AGENDA
CITY OF TAYLOR, TEXAS
PLANNING & ZONING COMMISSION MEETING
CITY HALL COUNCIL CHAMBERS
400 PORTER STREET
TAYLOR, TEXAS, 76574
JANUARY 14, 2025, 6:00 PM

1. Review and approve minutes from the meeting held on December 10, 2024. *Courtney Peres*
2. **PZ 2024-2368** Consider Disapproval of The Foundry Preliminary Plat, generally located at the intersection of Old Granger Road and North Main Street, legally described as a 10.69 - acre tract of land in the J. Pharrass Survey, Abstract No. 495, more particularly described by the Williamson Central Appraisal District Parcel R102540, Taylor, Williamson County, Texas
Courtney Peres

PZ-2024-2368

**Old Granger Road
Preliminary Plat
Location Map
Approximately 10.7 acres**

400 North Oklahoma Dr., Suite 105 Celina, Texas 75009	FIRM # 10194503	Tel. No. (469) 501-2200 www.kimley-horn.com
Scale 1" = 50'	Drawn by MJS	Checked by DRA
Date Dec. 2024	Project No. 069412807	Sheet No. 1 OF 2

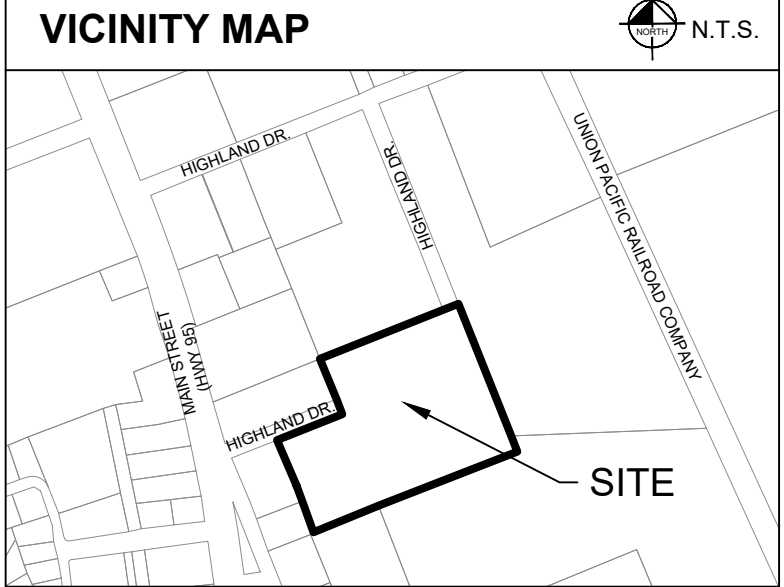
Sheet 1 of 2

1. Street Name to be Highland Drive
2. Verify and update easement to include "Pedestrian Access Easement"
3. Include all recording information for Main Street (aka SH 95)

4. Show and notate locations of civic spaces per regulating plan
5. Repeat 40' pipeline easement information here to notate location within ROW dedication

6. Notate area of proposed water easements (e.g. sqft, acre)
7. Please verify if phasing of the development is planned. If so, provide a phasing plan
8. Provide the lot/block and streets table in tabular form.

13. Remove non-plat elements shown
14. Verify Street Name to be Highland Drive
15. Is this portion of proposed ROW for Kerlin Lane being platted? If so, update boundaries or remove information and provide updated information accordingly.

16. Provide a tie to a corner of the original tract and a tie to the closest platted lot
17. Verify and update Update address to "Granger Road"
18. Update permit number

19. Label legend item (e.g. Abbreviations Legend)
20. Verify and update linetypes shown and remove lines not applicable to this plat/include applicable linetypes

21. (Typical) All lot corners to be squared at intersections
22. Recommend placing all tables in one consolidated area (including street and lot/block)
23. Sheet size submitted is a 22"x34". Verify and update scale text

24. Verify and update Lot 2 to include this public utility easement
25. Is this existing 10-ft PUE along Mark Gregg Street to be relocated or removed per this plat? It is now located in ROW dedication. It appears existing sanitary sewer is located within this area.

26. Please verify if these are intended to be used for water meter (meter vaults) locations
27. Notate easement width and type for easement shown
28. Note that all utility easement widths are subject to requirements found in the Taylor Engineering Manual Sec. 1.8. A minimum 20-ft wide easement is required.

29. Provide graphic in legend for monuments/IRs
30. Provide all street centerlines and include bearing/distance/curve data. This is also intended to verify tie-in to existing streets

31. Applicant is responsible for noting location of sidewalks on the plat per Taylor LDC 3.8.1.17 SIDEWALKS
32. What is the intent of this curve in the roadway? It appears there is adequate space to provide a straight alignment

33. Based on future extension of this street, is it feasible to shift the centerline of this ROW east (+/- 8'-10') to allow for the street to extend mostly along this existing 39.77 acre tract?
34. Verify and update Lot 3 to include this access easement
35. Provide acreage of existing adjacent lots/tracts.
36. Recommend placing this bearing directly on the plat to remove the line table completely.
37. Show and label location of existing Granger Road ROW.
